RE: Georgia Power Company's 2022 IRP, Docket 44160.

On January 31, 2022, Georgia Power Company ("Company") filed its 2022 Integrated Resource Plan ("IRP") with the Georgia Public Service Commission ("Commission"). Pursuant to Commission Rule 515-3-4-.04(1)(c), the Company filed its Environmental Compliance Strategy ("ECS") as part of the 2022 IRP. As part of the ECS the Company includes a detailed overview of the applicable current and proposed environmental regulations, existing environmental law, potential legislation, and a comprehensive strategy for compliance. In the ECS accompanying the 2022 IRP, the Company informed the Commission that the proposed decertification of Plant Wansley Units 1 and 2 presented a unique opportunity for the Company to consider an additional closure option for the Plant Wansley Ash Pond. Specifically, as described in the Company's Direct Testimony of Dr. Mark Berry and Mr. Aaron Mitchell:

Section	Page Reference	Revision
1.2 Summary of the 2022 ECS	3	CCR bullet revised to include Plant Wansley closure by removal strategy
	4	Strategy Schedule figure updated with new closure dates and moved landfill from "active" section.

Figure 4.4-1 2021 Environmental Compliance Strategy Schedule

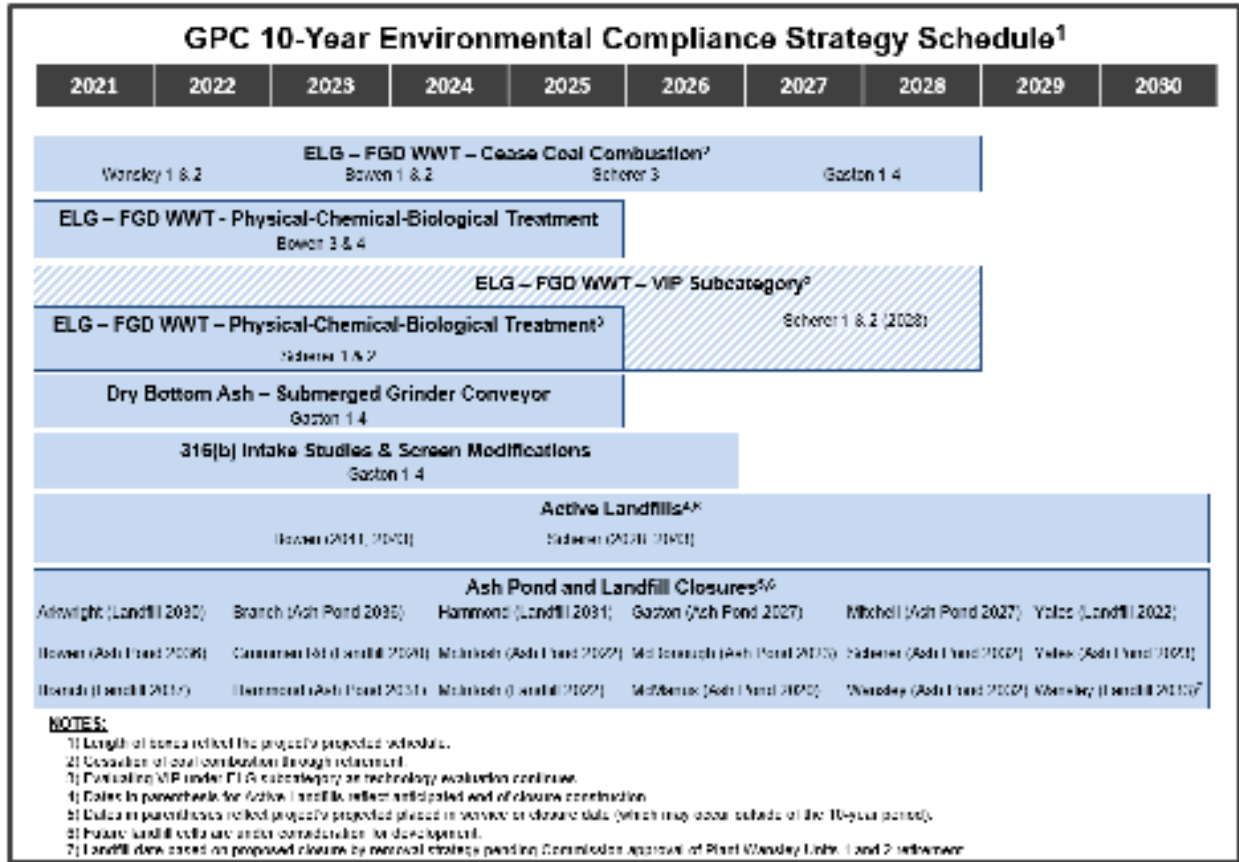
4.4 Strategy and Schedule	88	Figure 4.4-1 2021 Environmental Compliance Strategy Schedule -- updated with new closure dates and moved Wansley landfill from "active" section.
